DESCRIPTIVE REPORT

Type of Survey Hydrographic.....
Field No. RA-10-21-97.....
Registry No. H-10767.....

State Alaska.....
General Locality ... Southwest Alaska Peninsula ...
Sublocality Anguvik Island and Vicinity.....

Descriptive Report to Accompany Hydrographic Survey H-10767

Revisions in Red from NOAA
Survey H-10767 (1997)

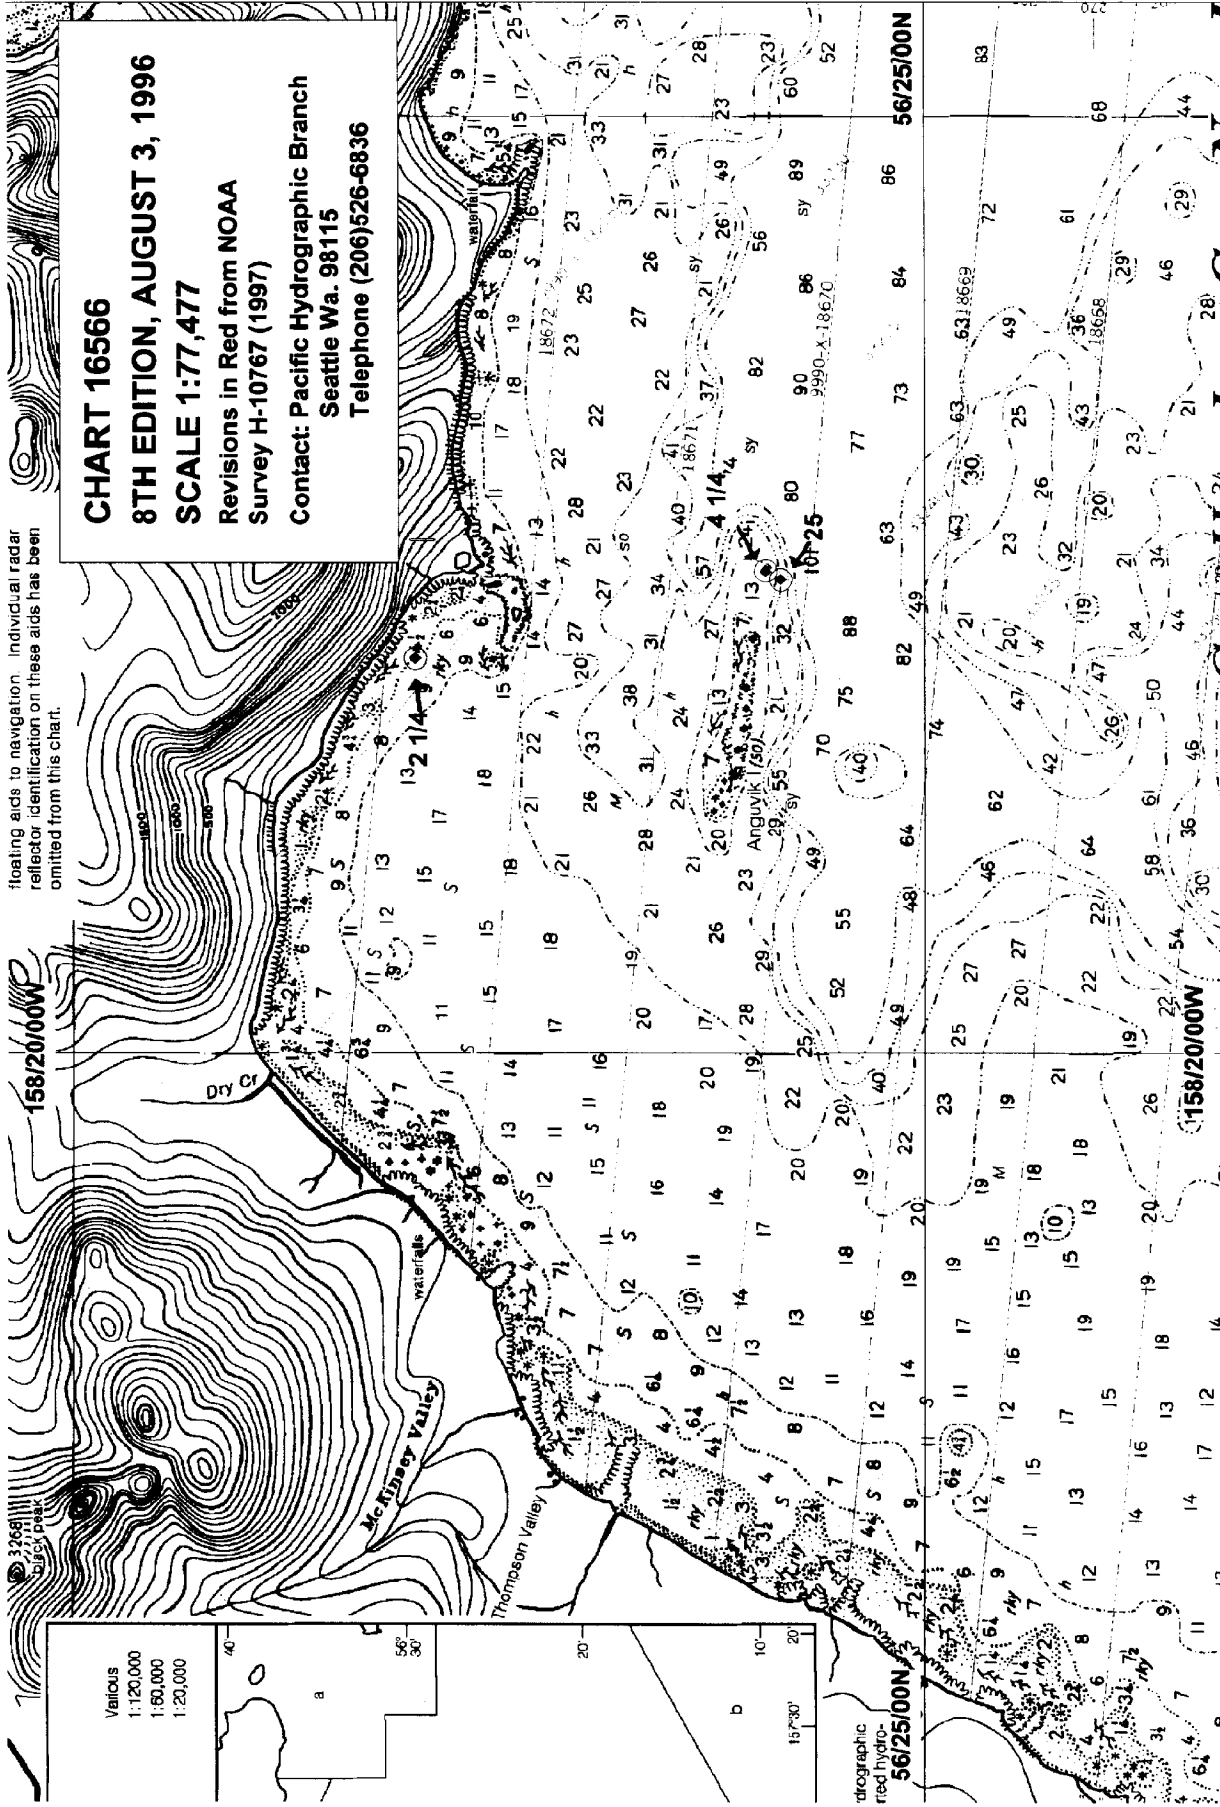
During office review of hydrographic survey H-10767, Alaska, Southwest Alaska Peninsula, Vicinity of Anguvik Island two additional shoal soundings were found and are considered to be a potential danger to navigation. Also, a 3 fathom depth which was reported by the NOAA Ship RAINIER as a potential danger to navigation on August 28, 1997, was found to be a 25 fathom depth after further review and therefore considered not to be a danger to navigation.

<u>DANGER TO NAVIGATION</u>	<u>LATITUDE(N)</u>	<u>LONGITUDE(W)</u>
Erroneous 3 fathom depth	56/25/51.50	158/14/57.36
4 1/4 fathoms	56/25/56.76	158/14/51.96
2 1/4 fathoms	56/27/59.80	158/15/47.27
